## PIC18F2X1X/4X1X Rev. B3 Silicon Errata

The PIC18F2X1X/4X1X Rev. B3 parts you have received conform functionally to the Device Data Sheet (DS39636C), except for the anomalies described below. Any Data Sheet Clarification issues related to the PIC18F2X1X/4X1X will be reported in a separate Data Sheet errata. Please check the Microchip web site for any existing issues.

The following silicon errata apply only to PIC18F2X1X/4X1X devices with these Device/Revision IDs:

**FIGURE 1: SCK PULSE VARIATION USING TIMER2/2**

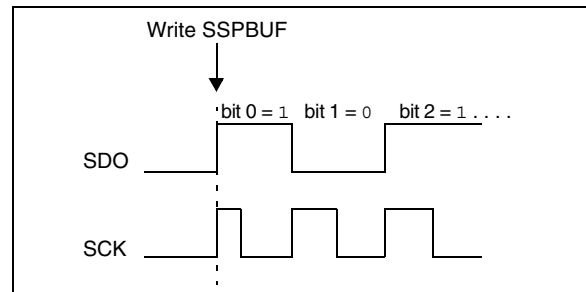
When the SPI is using Timer2/2 as the clock source, a shorter than expected SCK pulse may occur on the first bit of the transmitted/received data (Figure 1).

To avoid producing the short pulse, turn off Timer2 and clear the TMR2 register, load the SSPBUF with the data to transmit and then turn Timer2 back on. Refer to Example 1 for sample code.
